LOCAL REVIEW BODY

EAST RENFREWSHIRE COUNCILLOCAL REVIEW BODY19 January 2022Report by Deputy Chief ExecutiveREVIEW OF CASE - REVIEW/2021/11

CHANGE OF USE OF GROUND TO GARDEN GROUND AND ERECTION OF TWO STOREY SIDE EXTENSION AND BOUNDARY FENCE AT 17 INVEREWE WAY, NEWTON MEARNS, EAST RENFREWSHIRE, G77 6XH.

Figure 8: Massing characteristics of properties in the immediate vicinity (within 100m):

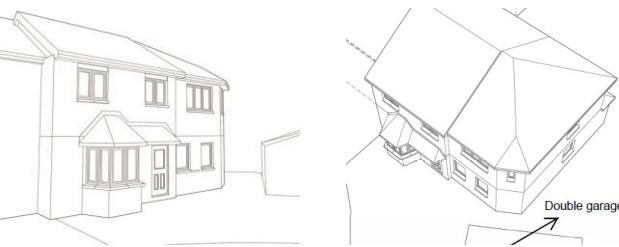
- 8.11 Perhaps most significantly it illustrates that approval continues to be granted for developments that display both hipped and gable rooflines, not identical to the original dwelling. East Renfrewshire Planning Office effectively deeming these developments not to be to the detriment of the appearance of the property or the surrounding area. Please see for example Figure 8E above - 10 Crarae Place (Ref 2020/0838/TP).

Drawing title:
Block Plan - as Proposed
Project:
**Proposed extension at
17 Inverewe Way**

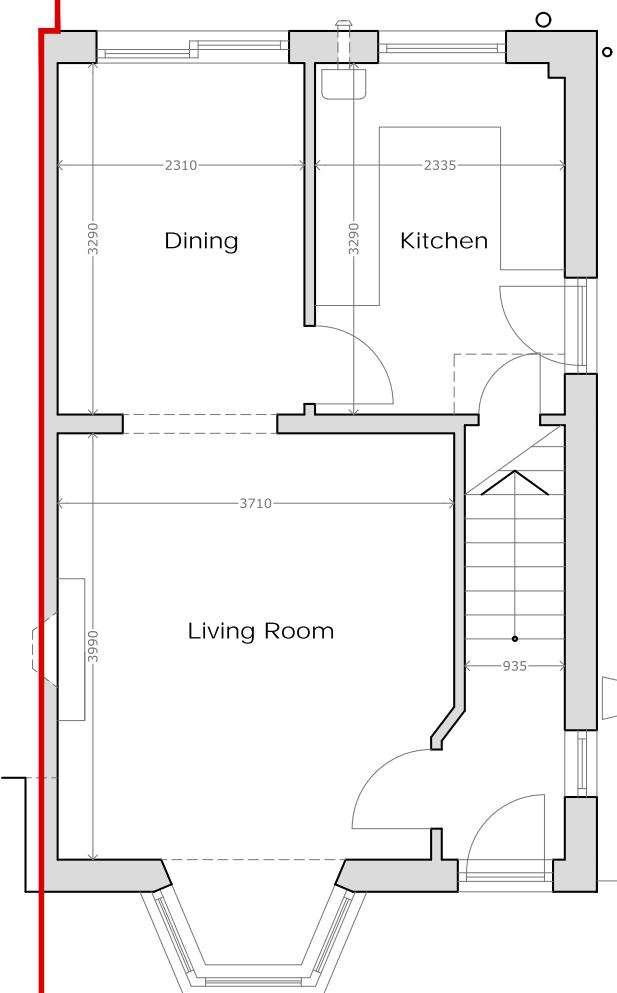
1. The proposal is contrary to Policy D6 of the adopted East Renfrewshire Local Development Plan as the proposed change of use would lead to the loss of structural landscaping to the detriment of the character, amenity and setting of the wider housing development.

2. The proposal is contrary to Policy D1 of the adopted East Renfrewshire Local Development Plan as its size, scale and massing would be significantly out of keeping with the predominant built form of the street resulting in a significant loss of character to the surrounding area.

3. The proposal is contrary to Policy D14 of the adopted East Renfrewshire Local Development Plan as the size, scale and massing of the extension would dominate the original form of the dwelling resulting in a significant loss of character to the dwelling.

4. The proposal is contrary to the Supplementary Planning Guidance on Householder Design as the extension does not have the same roof design as the original house, would be considerably more than 50% of the frontage of the dwelling and is not sufficiently set back from the frontage of the dwelling. Consequently, the size, scale and massing of the extension would dominate the original form of the dwelling resulting in a significant loss of character to the dwelling and surrounding area.

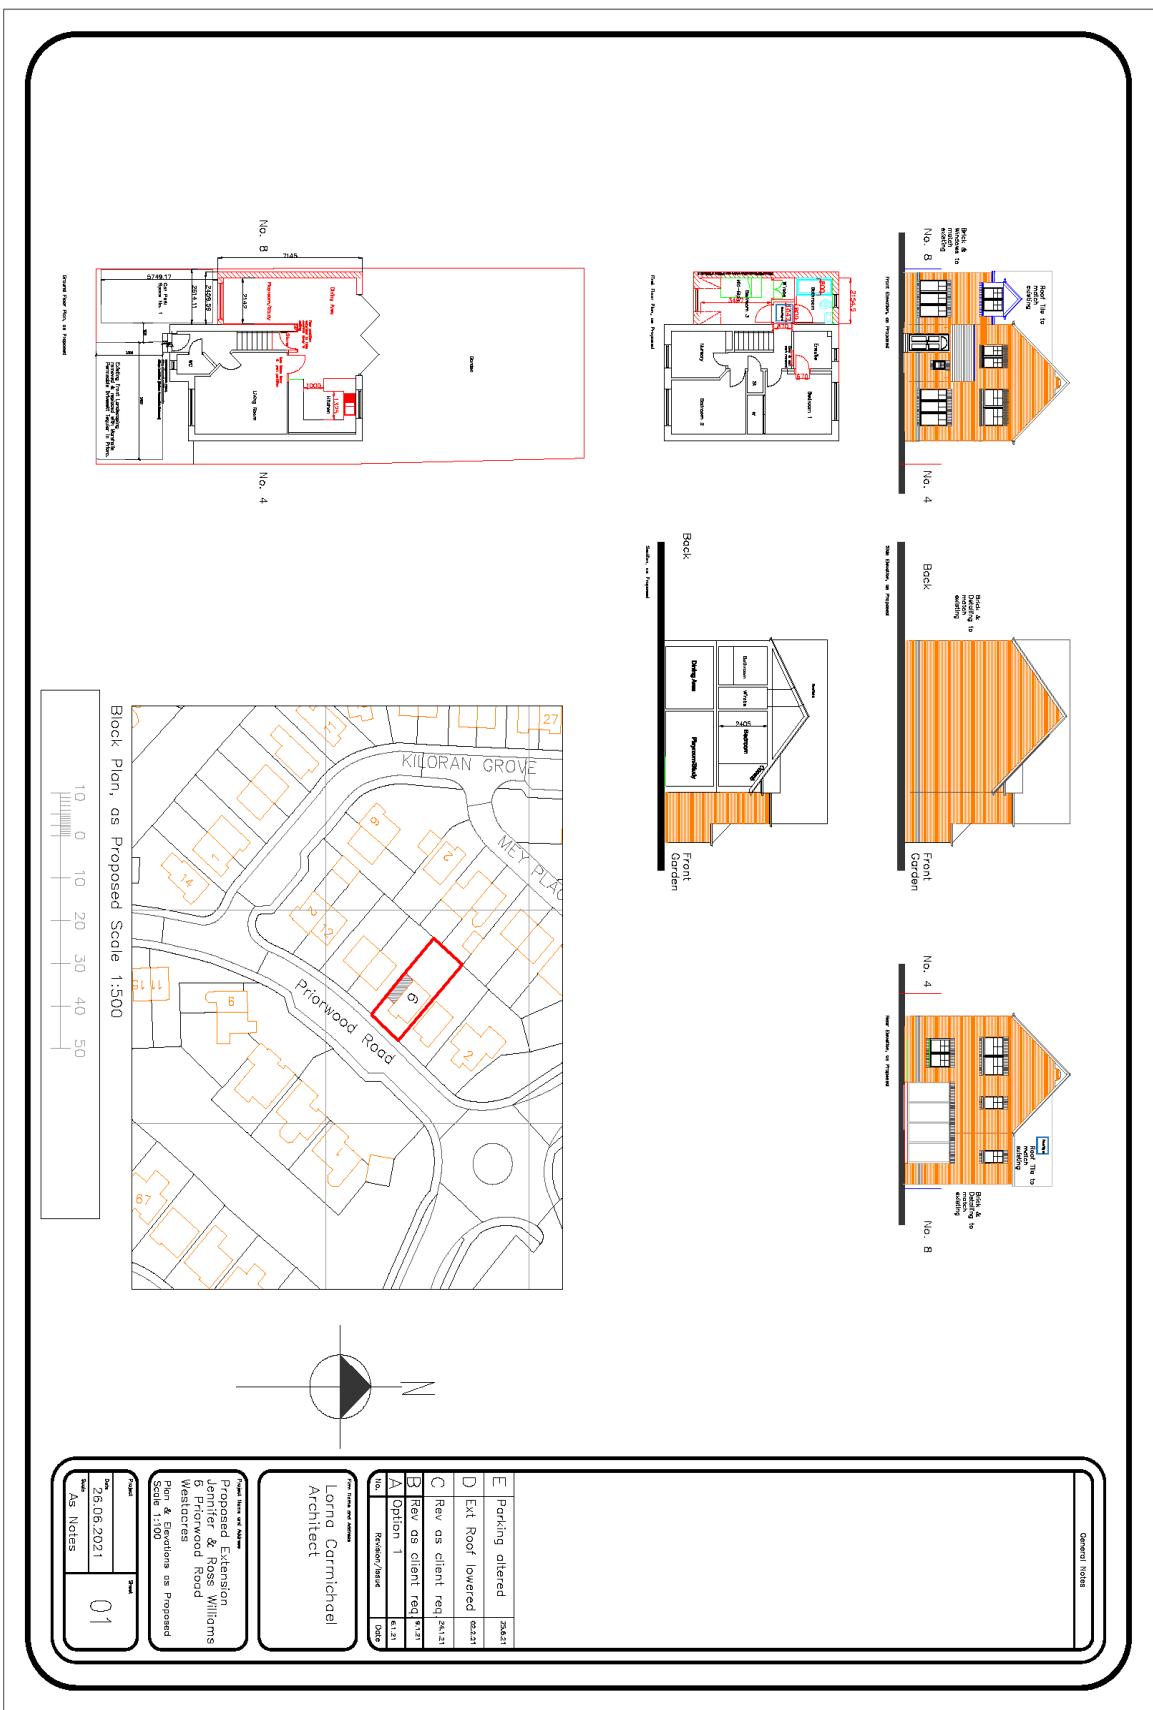
1. The proposed development constitutes overdevelopment of the site with a lack of sufficient/acceptable off street parking to the detriment of road and pedestrian safety at the locus. The proposal is therefore contrary to Policies D1 and D14 of the adopted Local Development Plan and Policy D1.1 of the Proposed Local Development Plan 2.

2 generous car parking spaces have been provided for a 3 Bedroom domestic property (Refer to Dwg No. 01 Rev E). In accordance with East Ren Adopted LDP (D1 & D14), LP Plan 2 (D1.1) and Part 3 of the ER Roads Development Guide. Extension has been designed sensitively, in keeping with the area. Proposal designed to prevent site over-development. Other similar developments have been allowed. 4-5No. visitors parking bay is located across the road, again preventing over development of the area.
